Design, Supply, Installation, Testing & Commissioning of 230kV AIS Bay Extension at Parbatipur 230kV AIS

Contract No.: PGCB/EXIM BANK/LOC-2/230kV/SS-PAR

Clarification- 01

Addendum No. 01

Proposed Optical Communication Scheme for Parbatipur-Bogura 230 KV Line (CKT- 3 & 4)

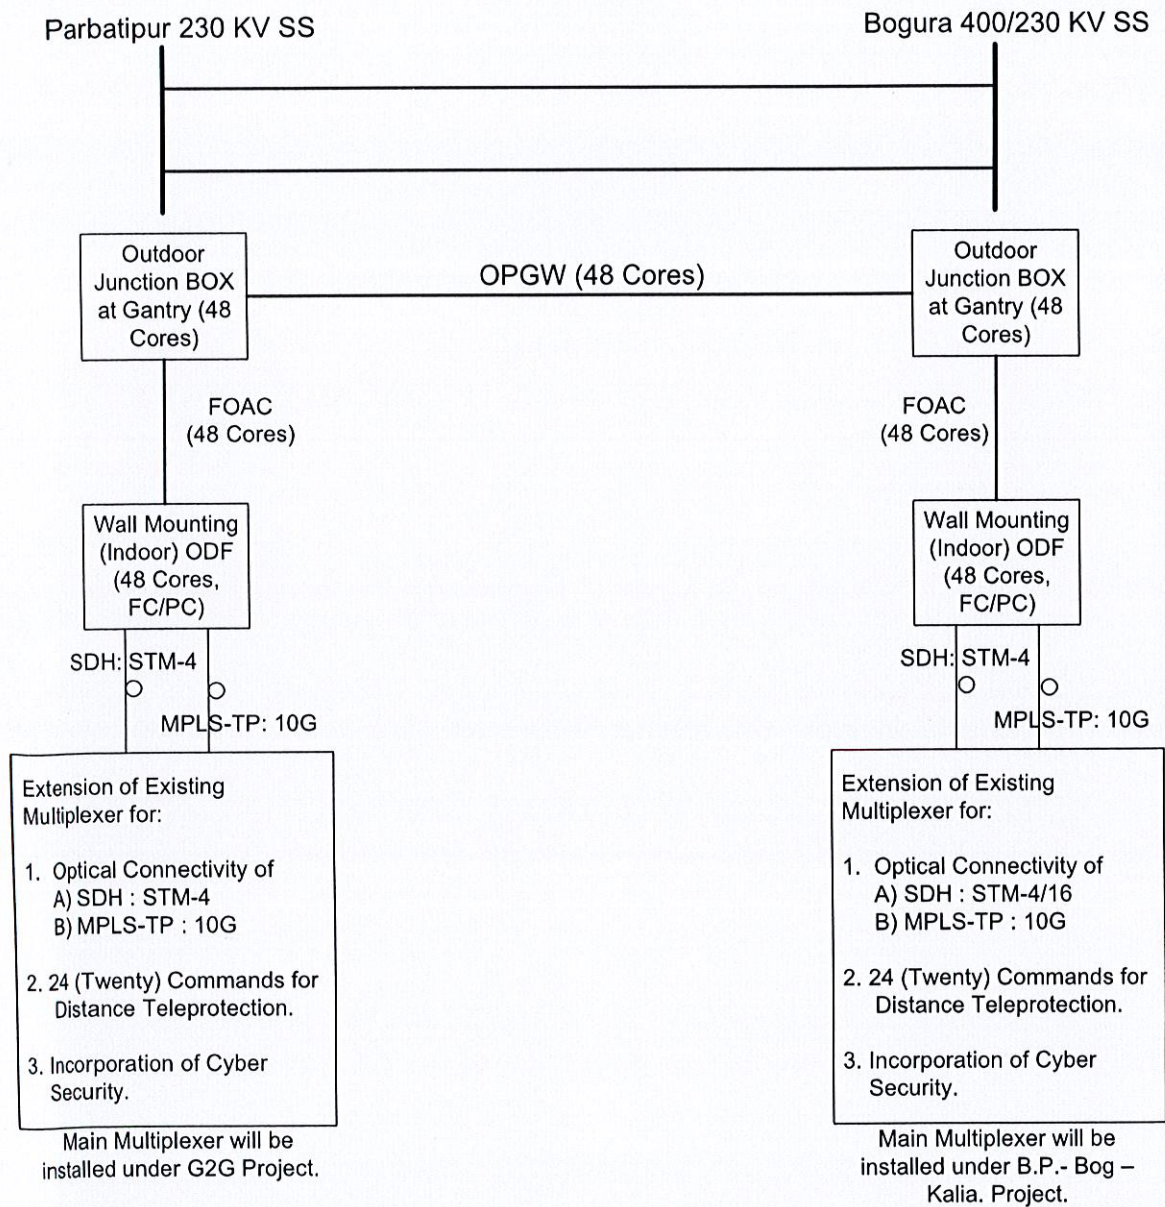
14.	Vol 3 (Pg no- 28) - 11.1 Fibre Optic Multiplexer Equipment for Communication and Protection	We understand that extension of existing fibre optic multiplexer equipment at local and remote end Substation for protection & communication are under bidder scope. *Existing Telecom panels are from GE or ABB. Kindly confirm local end make is GE or ABB?	Refer to attachment 1, 2 & 3 of addendum-1

Optical Communication Scheme drawing is added in the drawing at the end of section-18 as Drawing SI no 20.7 and attached as attachement-03

Along with the above mentioned items if any additional items are needed in line with the Drawing SI No.: 20.7: "Proposed Optical Communication Scheme for Parbatipur-Bogura 230 KV Line", Volume 2 of 3 of the bidding documents, that shall be supplied and installed within contract price. No additional payment shall be made in this regard. *Existing Telecom panels shall be from ABB or GE.
11.2	A lot of Armoured Underground Optical Fibre (48 cores) cables from terminal box at gantry structure to MDF (Main distribution Frame) shall be designed, supplied, delivered, installed, tested and commissioned, including supply and installation of MDF and digital cables, for required part of substation each comprising of – i. One (01) lot of Underground optical fibre cable, armoured, 48 core ii. One (01) lot of Outdoor termination box
11.3	PLCC System:
	Deleted
